UNITED STATES  
DEPARTMENT OF THE INTERIOR  
BUREAU OF LAND MANAGEMENTFORM APPROVED  
OMB NO. 1004-0135  
Expires: November 30, 2000**SUNDRY NOTICES AND REPORTS ON WELLS**  
**Do not use this form for proposals to drill or to re-enter an abandoned well. Use form 3160-3 (APD) for such proposals.**5. Lease Serial No.  
NMLC029403B

7. If Unit or CA/Agreement, Name and/or No.  
NMNM71009A8. Well Name and No.  
PEARSALL QN 179. API Well No.  
30-025-00850-00-S110. Field and Pool, or Exploratory  
PEARSALL11. County or Parish, and State  
LEA COUNTY, NM**SUBMIT IN TRIPLICATE - Other instructions on reverse side.**

Mack Energy Corporation Proposes to Plug well as follows:

MACK ENERGY CORPORATION  
PEARSALL QUEEN UNIT #17  
Sec 5 T18S R32E 2310 FSL 2280 FWL

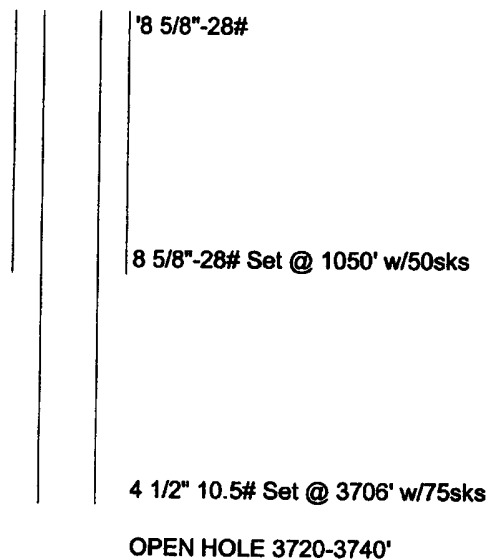
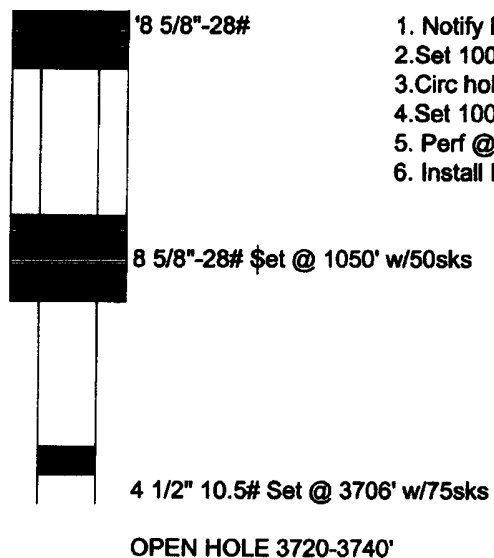
Perforate 4 1/2" casing @ 1280' & squeeze w/sufficient cement (40 SX) to have  
Solid Plug F/1280-1180' - TAG
